CCO #03d-007

Project: 0483-01 - Perris High School No. 4
32255 Leon Road
Winchester, California 92596

Change Order #03d-007: CE #483 - RFI #1216: Outfield Fencing Requirements

Potential Change Order #03d-015 : CE #483 - RFI #1216: Outfield Fencing Requirements

2 BALLFIELD FENCE DETAIL A
 A1.1.1 1 1/2" = 1'-0"

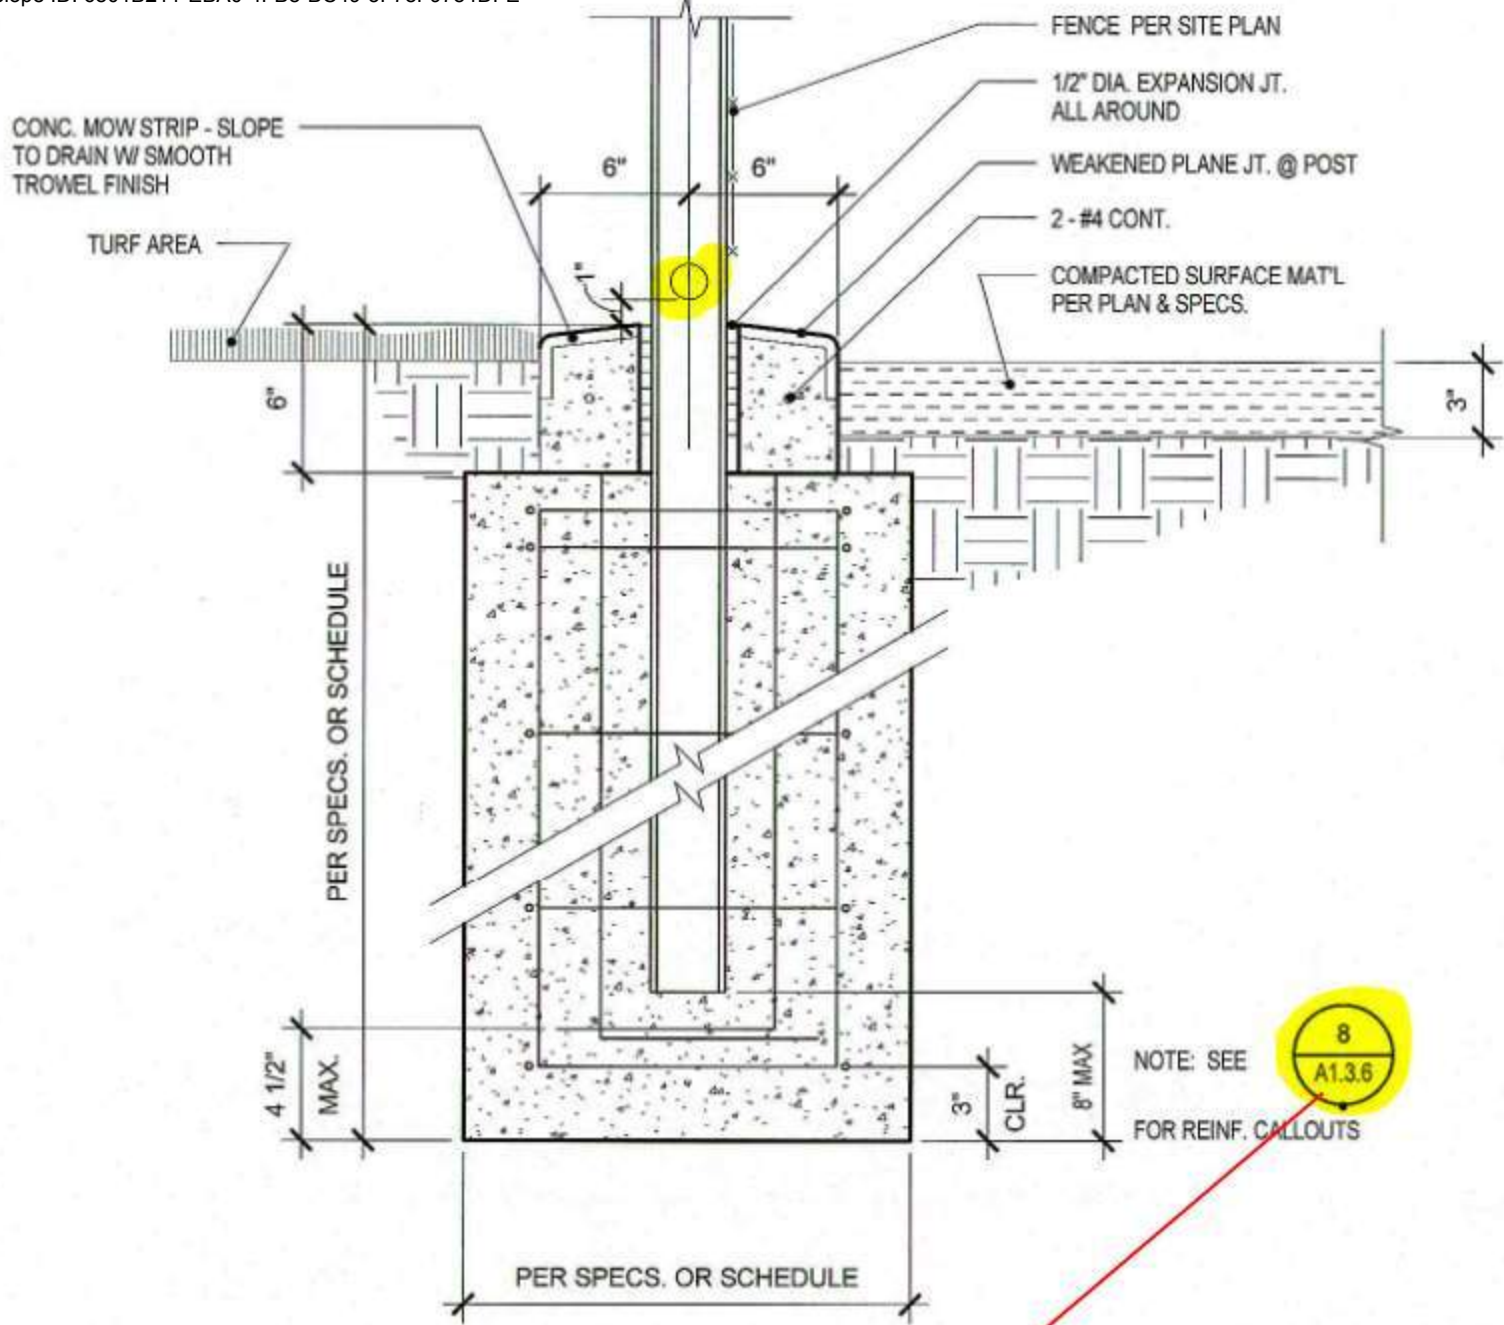
In regards to the bottom rail at said outfield fence locations, while detail 2/A1.3.6 depicts a circle at the bottom of the fence post, there is no nomenclature specifically calling this as a bottom rail. Based upon the overall site plans, the line hatching and pink color directs the Contractor to detail 1/A1.4.1. Said detail calls for tension wire which is as the Contractor has installed. Further, as per section 32 31 13 Chain link Fencing, installation subsection D, Contractor is to provide tension wire, 2" above grade, stretched between terminal posts. Based upon our review, the Contractor has fulfilled his obligation in this requirement.

Please advise if the District's intent is to have the Contractor install the safety padding as well as the bottom rail.

See attached excerpts from the construction documents. Safety padding and bottom rail is required.

FOUL POLE DETAIL

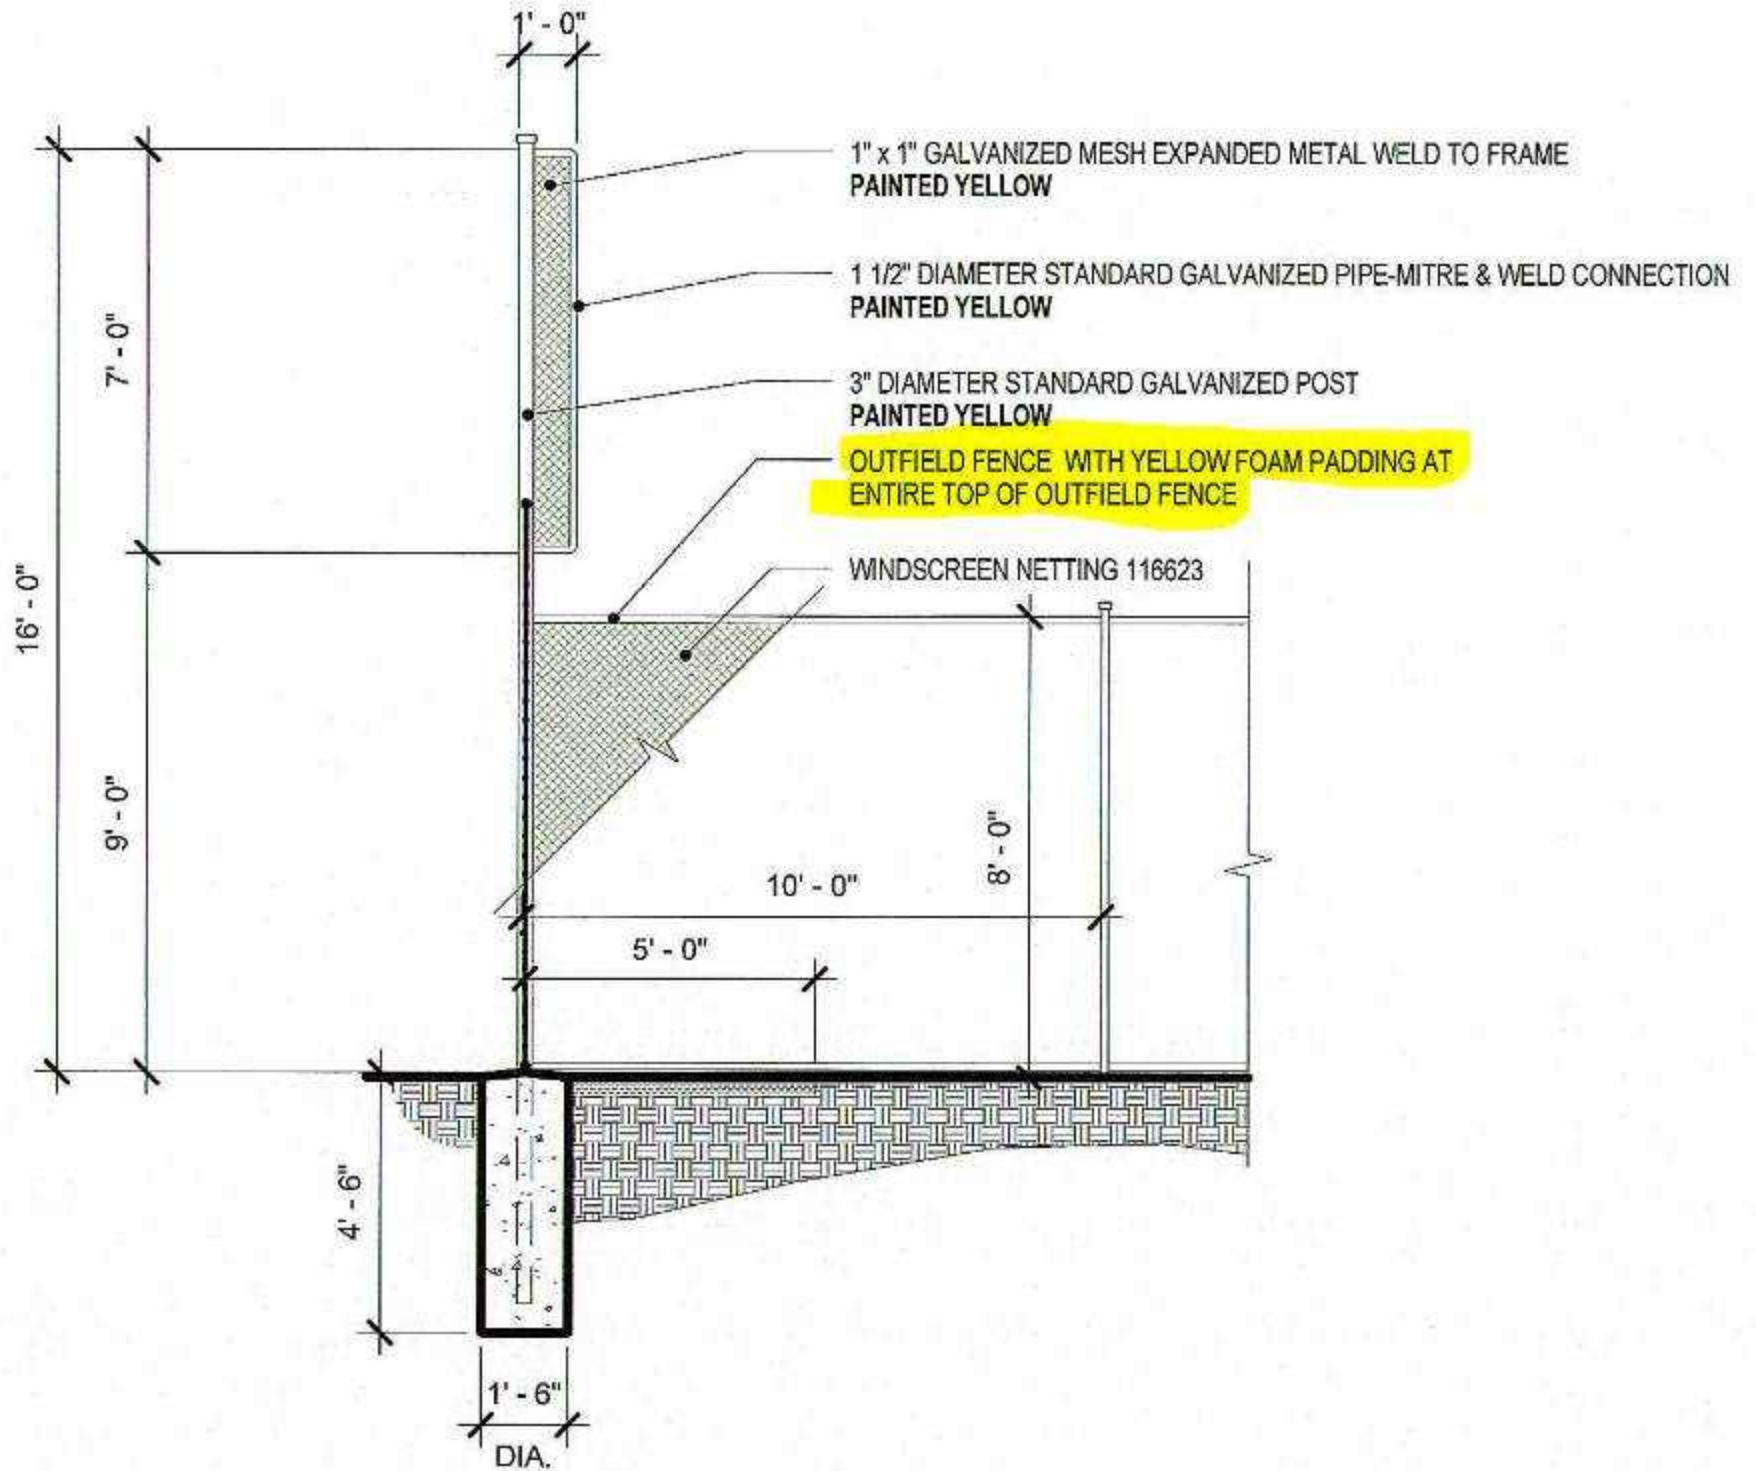
Foam padding at outfield fence is required per detail 5/A1.3.6.

Based upon our review of the Contract Documents, it would appear that the safety padding at the top of outfield fencing, as previously discussed during various Owner's meeting, is not detailed nor specified, and thus not owed by the Contractor.

Added cost not accepted.

Install as part of Contract Scope.
